**CLARKE COUNTY PLANNING COMMISSION  
TABLE OF CONTENTS  
February 27, 2018 Work Session  
March 2, 2018 Business Meeting**

**MINOR SUBDIVISION (MS-18-01) / MAXIMUM LOT SIZE EXCEPTION (MLSE-18-01)  
Stuart Properties, LLC – “Mesilla Farm East”  
March 2, 2018 Planning Commission Meeting  
STAFF REPORT -- Department of Planning**

**CERTIFICATE OF APPROPRIATENESS (CA-18-01)**  
**Core States Group (McDonald's Corporation)**  
**March 2, 2018 Planning Commission Meeting**  
**STAFF REPORT -- Department of Planning**

045-0526  
**A2.2**  
 ELEVATIONS

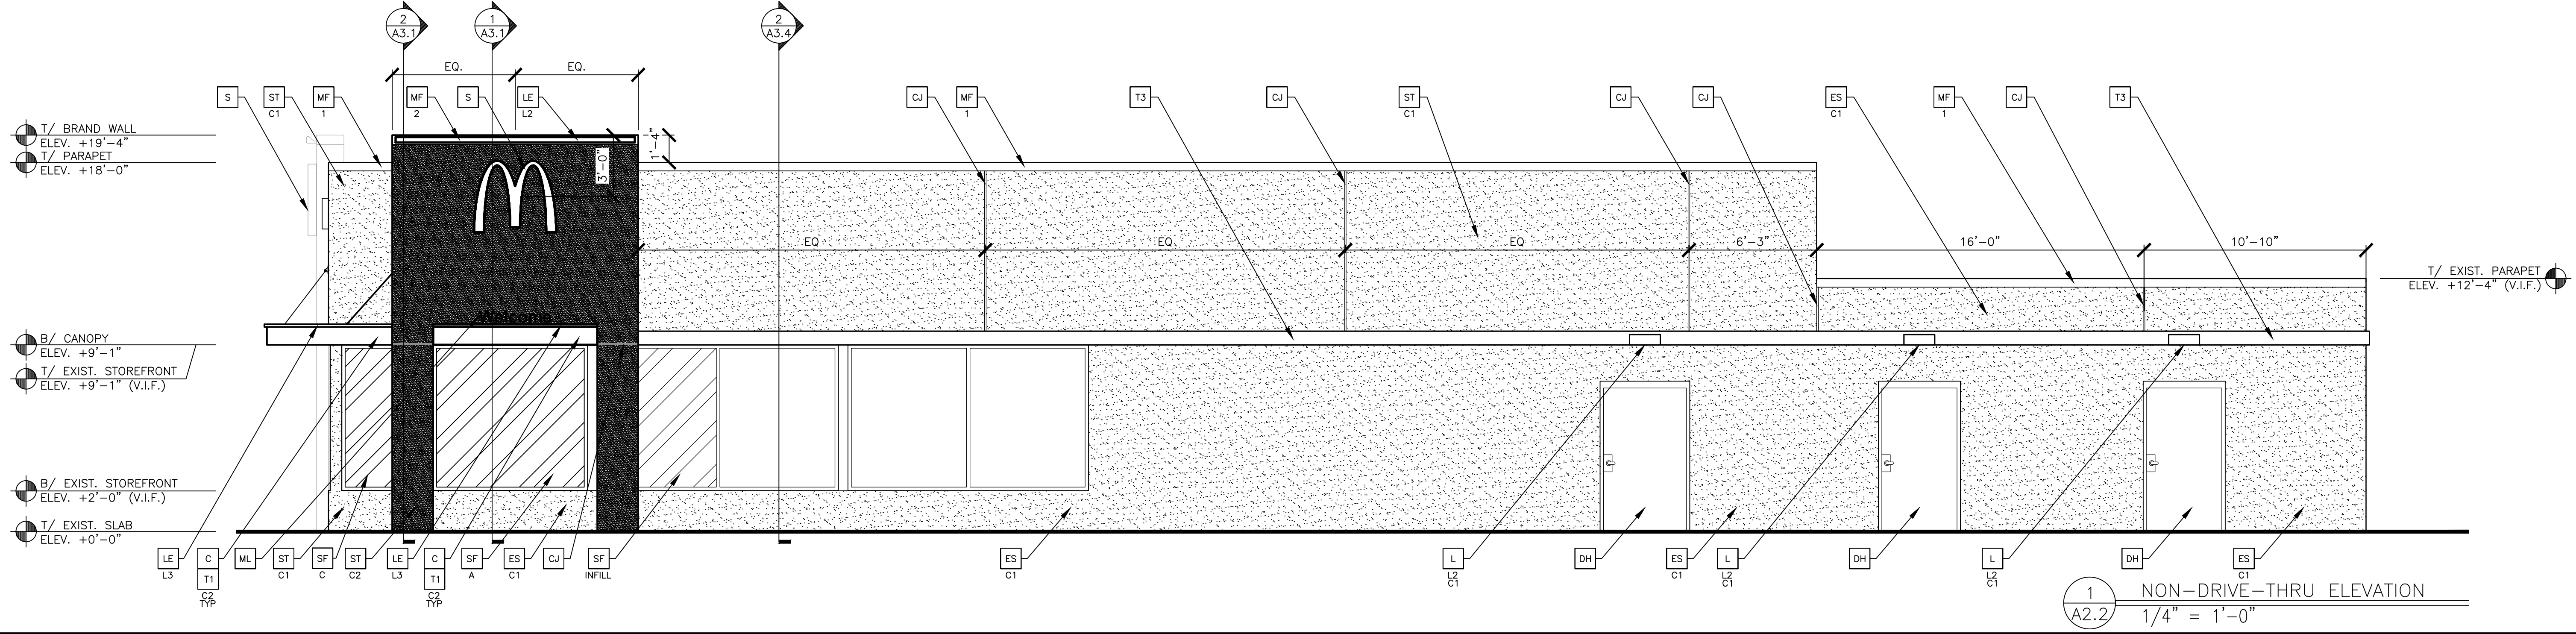
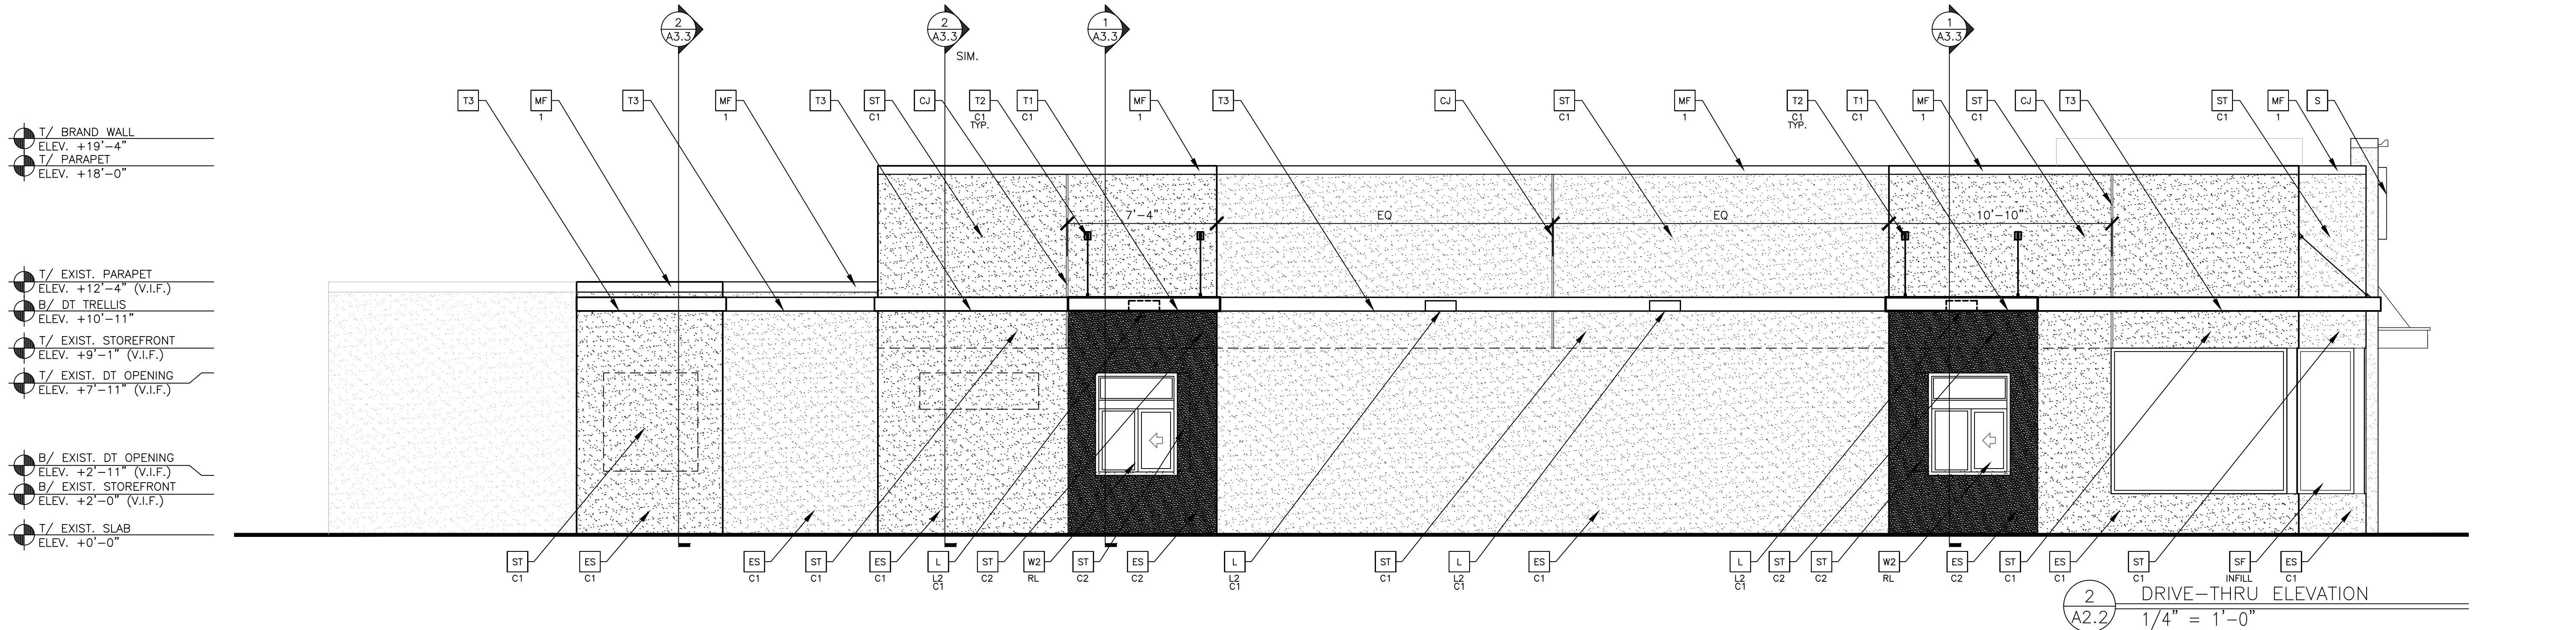
The request was routed to Maral Kalbian, Clarke County's consulting Architectural Historian, for review. Ms. Kalbian's comments were received February 15, 2018 and sent to the applicant via email the same day. The applicant's agent forwarded the comments to their design team and expect to submit a revised plan soon. The agent informed Staff that the computer generated color rendering submitted with the application is a generic example and not accurate to the actual elevations submitted. Unfortunately the elevation plans were not included in the 24" by 36" sized

site plan, and were instead attached to the proposed signage paperwork at only 8.5” by 11” size, which led to difficulty in review. Ms. Kalbian’s review was primarily based on the computer rendering. Staff has requested 24” by 36” sized revised elevation plans for review.

2. Roofs: The flat roof with parapet as drawn is an acceptable form for roofs in new commercial buildings. However, the continuous massing of the parapet should be broken up to provide for a less bulky massing of the building. The addition of a stepped parapet on the drive-thru side and an additional one on the east side similar to the one on the front of the building would help in making the building less bulky and more traditional in form. The division of the walls into vertical bays using pilasters could also help alleviate the solid massing of the building.
